Re: ENV-2002-2481-EIR

Canyon Hills Project

DEIR Comments,,,,,,,,,,,,,

Re: ENV-2002-2481-EIR
SCH#2002091018
Canyon Hills Project
DEIR Comments

100000 # 1

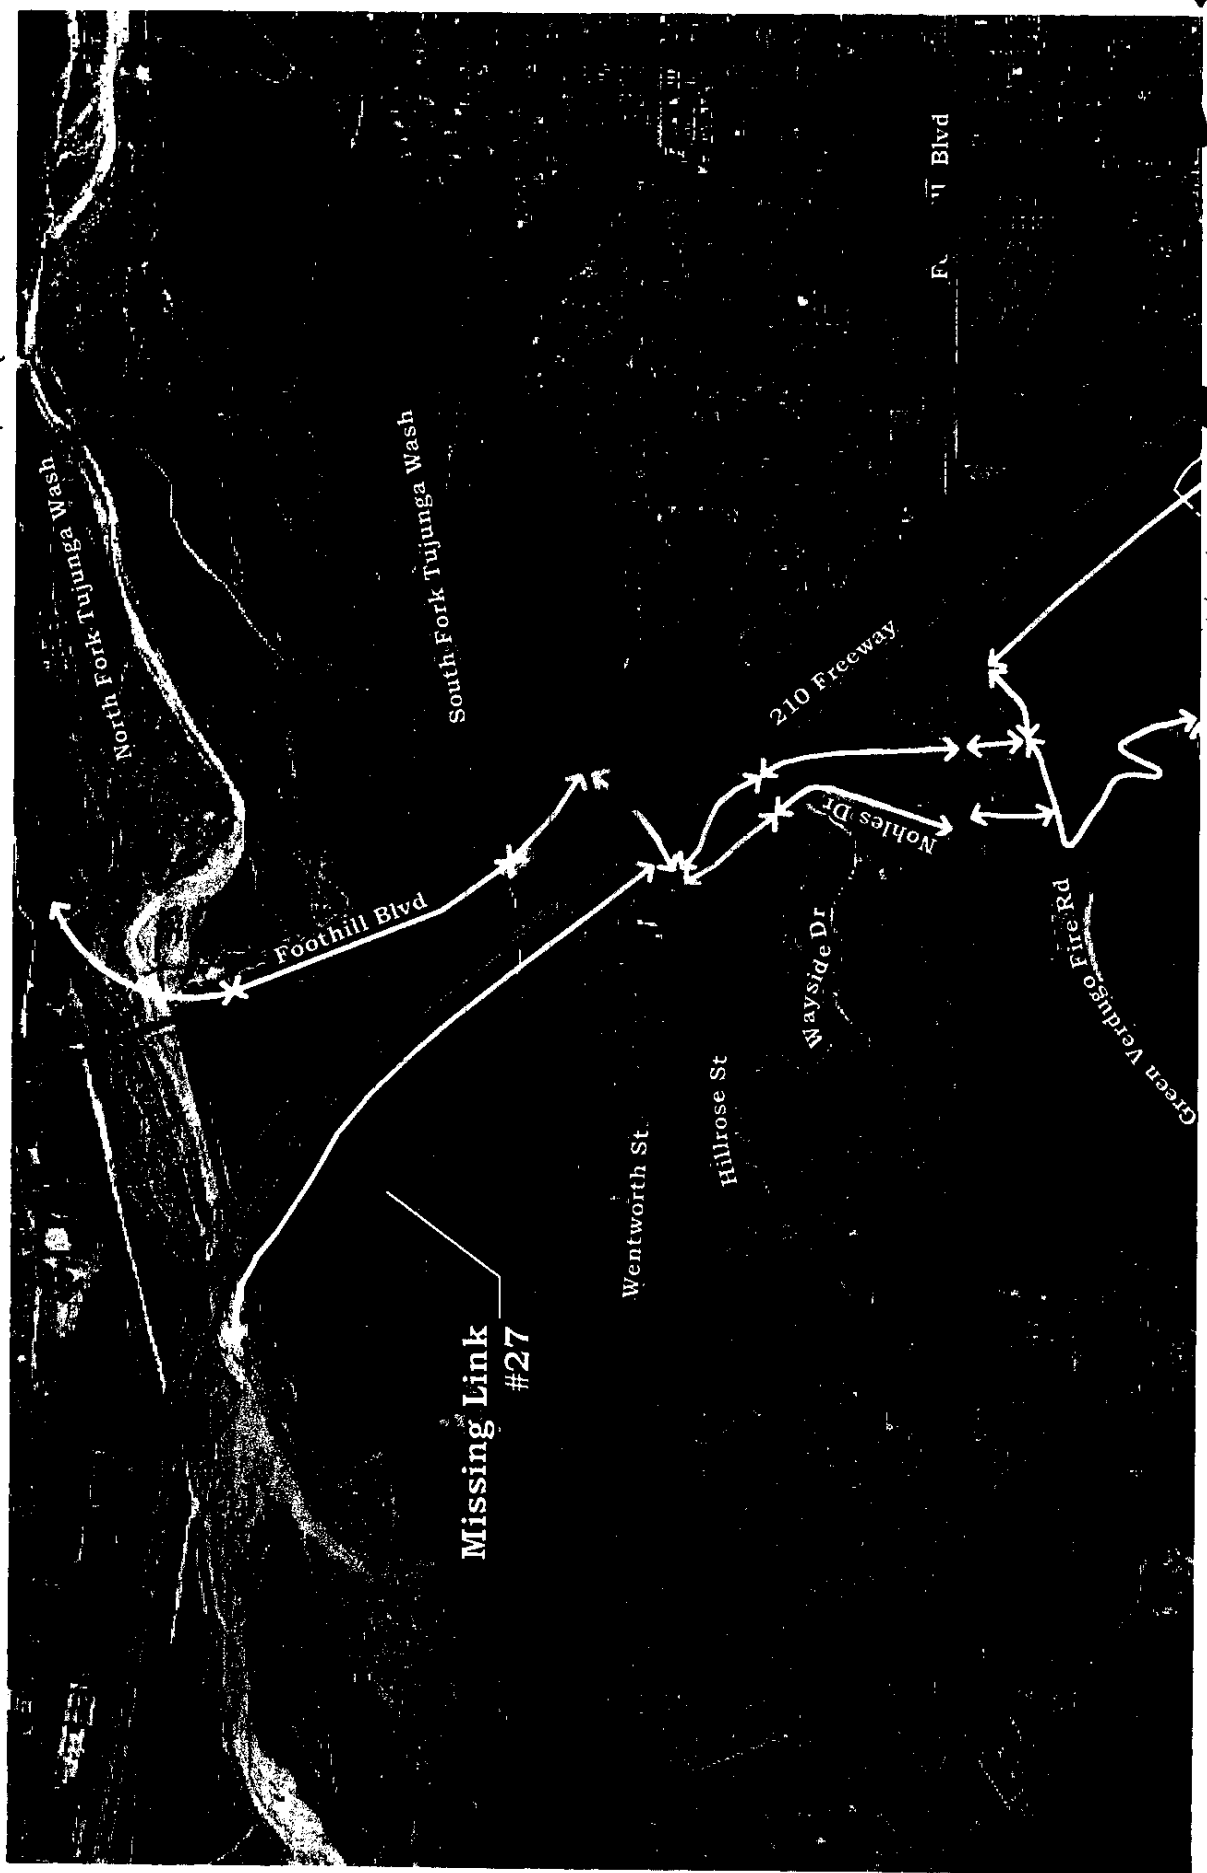
My comments contained within this critique of the "Canyon/Hills" DEIR pertain to specifically the region I am most familiar with near the northwestern tip of the proposed project boundary. My home (of five years +) lies within the "Missing Linkage # 27." (see photograph #1) I've lobbied city departments for two years now to retain an environmental easement on "Hidden Oak Dr., south of Apperson Street."

THIS IS MISSING LINK #27!!! NORTH OF THE 210 FREEWAY. Another house, fence, etc. here relegates all passage here north of the 210 in the Missing Link #27 to a hole in the fence at old Bob Robert's back yard at the west end of Yates Street.

The animal trail on the north side of the 210 is clearly visible in photograph #1, indicated by the red arrow. Hidden Oak Drive is indicated by the black triangle, the blue arrow points west toward the end of Apperson Street and the red marks represent a heavily-used wildlife corridor within Missing link #27 that I have dubbed 'the Invisible Link.'

The Invisible Link provides a viable corridor connecting the Verdugo Hills with Angeles National Forest on the north side of the 210 freeway. The DEIR makes no mention of this invisible link or the Upper Hanson Heights channel (a blue line stream) indicated on Exhibit 1 by the blue line. Therefore the DEIR is deficient in the regional wildlife movement studies.

Exhibit #1

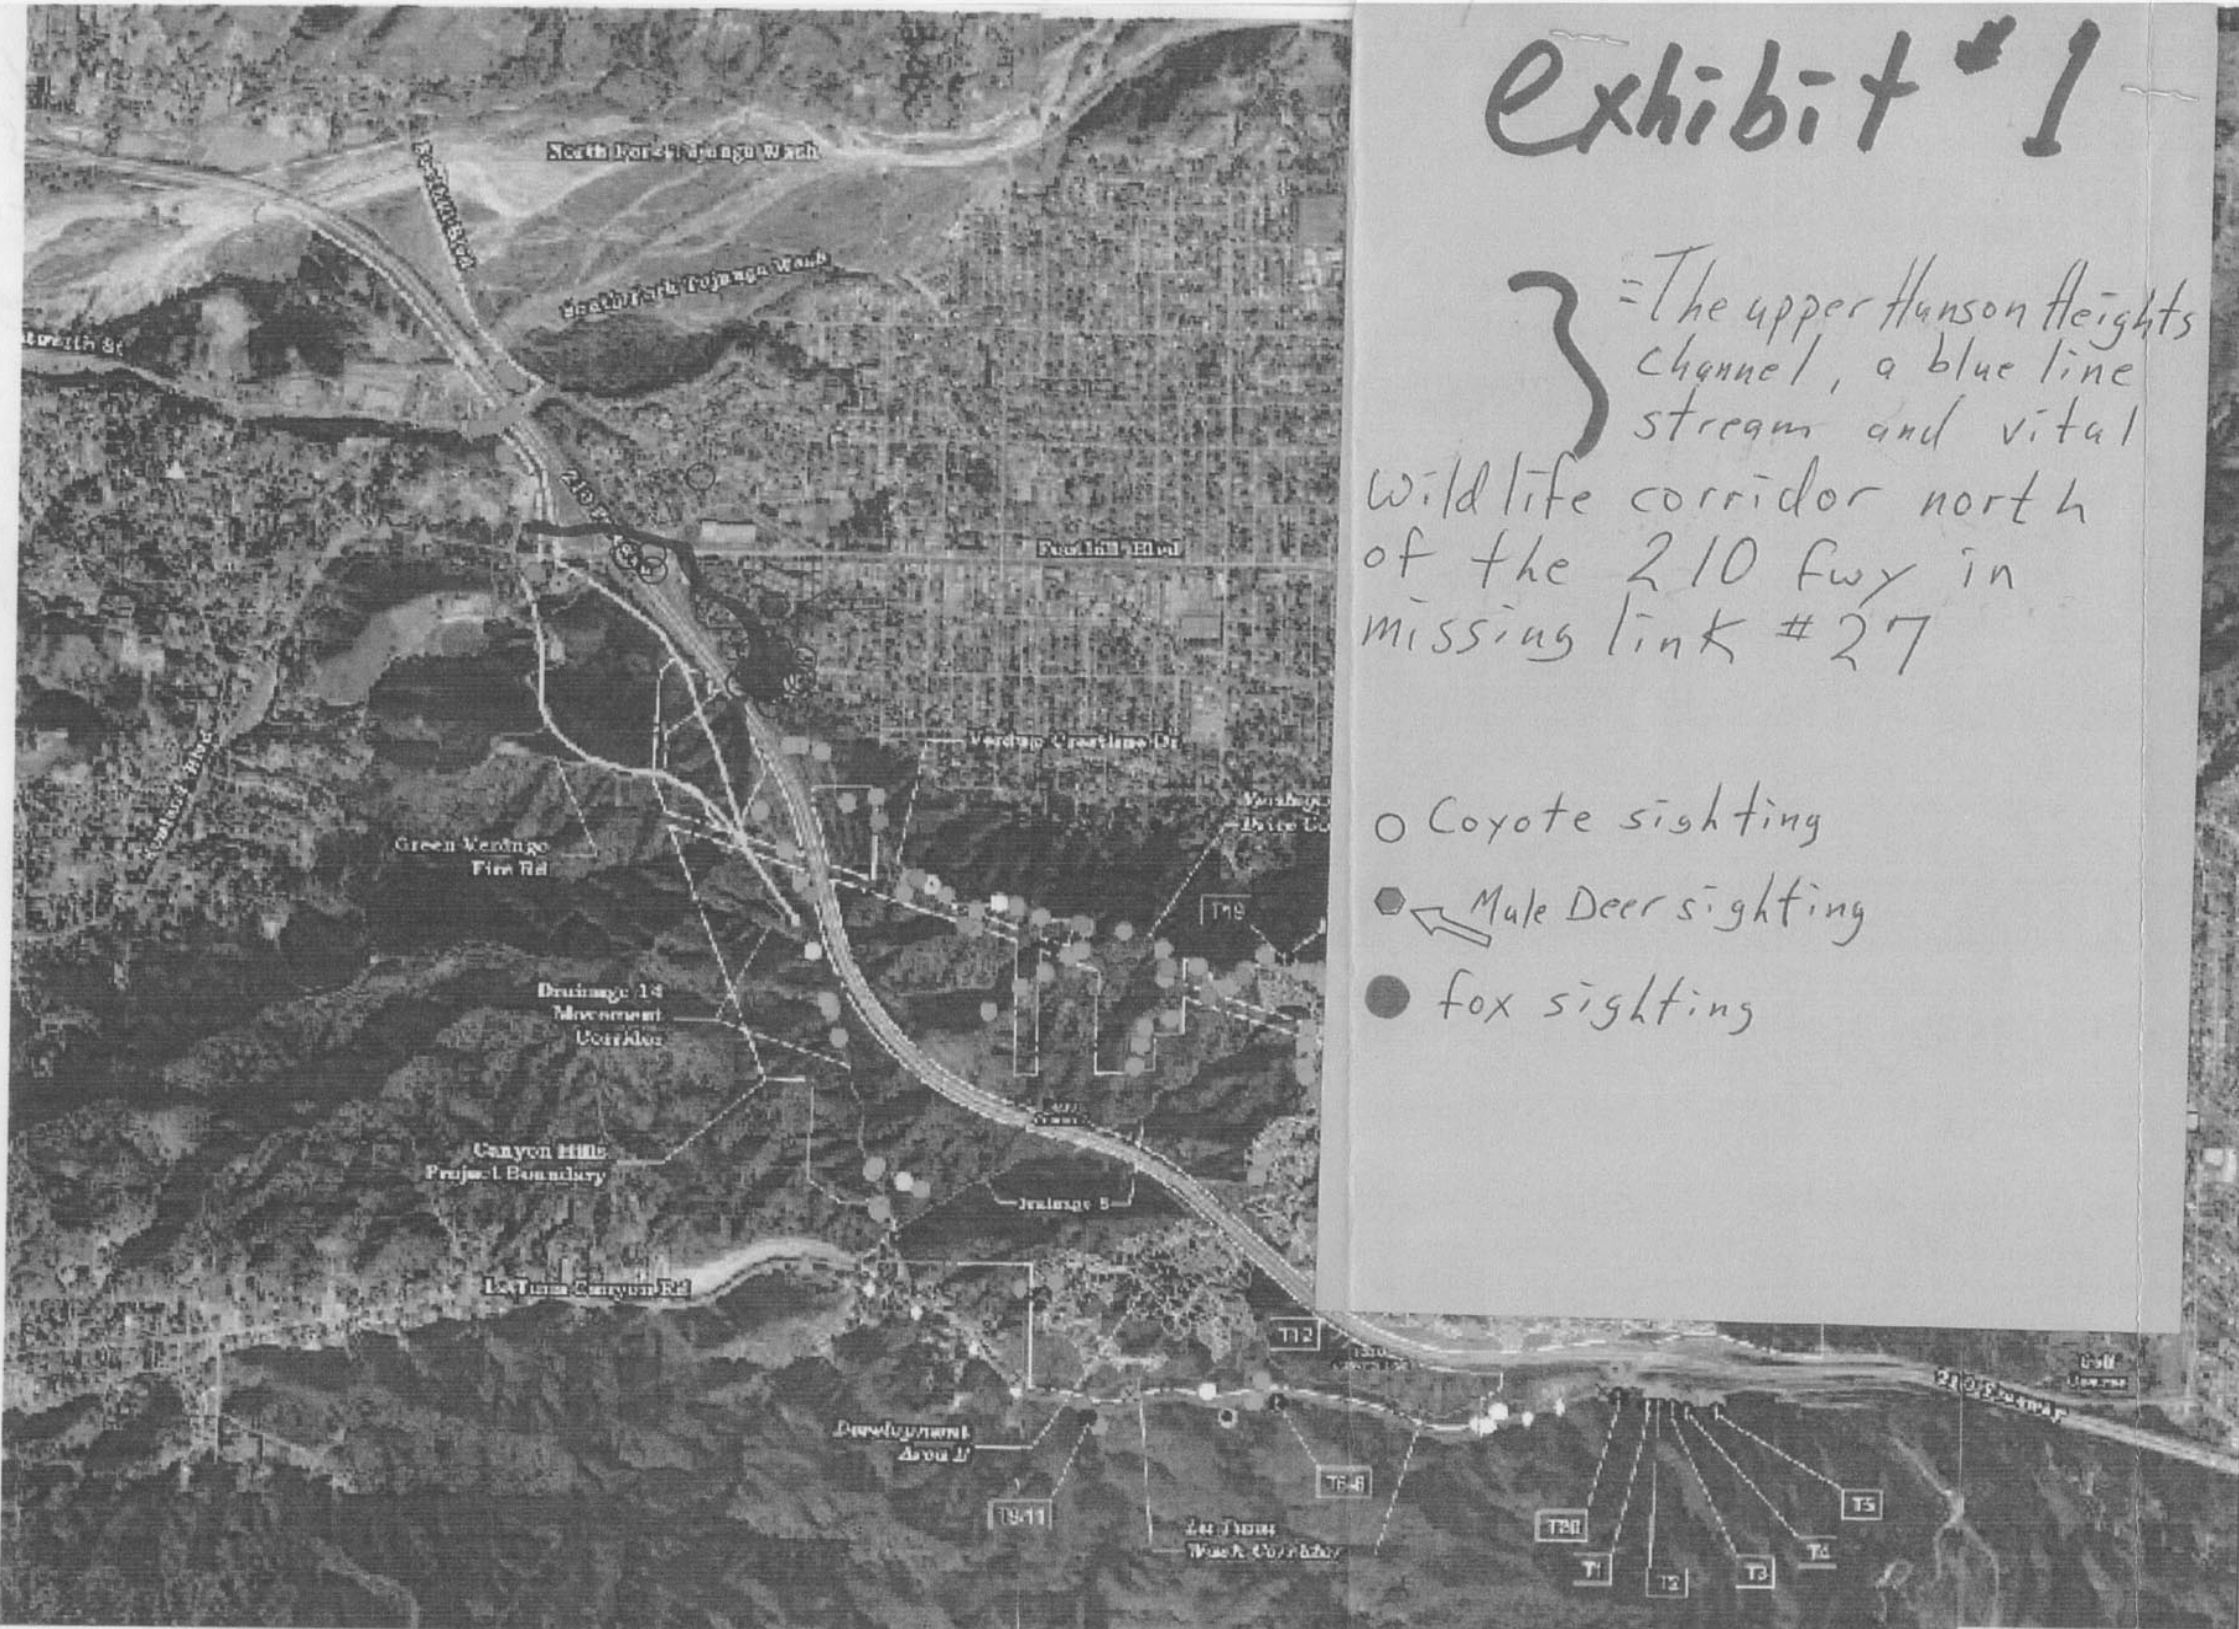
The Upper Hanson Heights Channel, a USGS blueline stream, crosses the 210 freeway at Hidden Oak Drive, South of Apperson Street within Missing Link #27. Exhibit #1 depicts the Upper Hanson Heights Channel as a blue line. Exhibit #1 also contains a partial listing of mule deer, fox and coyote sightings within a few hundred feet of this rapidly disappearing wildlife corridor on the north side of the 210 freeway.

The upper Hanson Heights channel, a blue line stream and vital wildlife corridor north of the 210 fwy in missing link #27
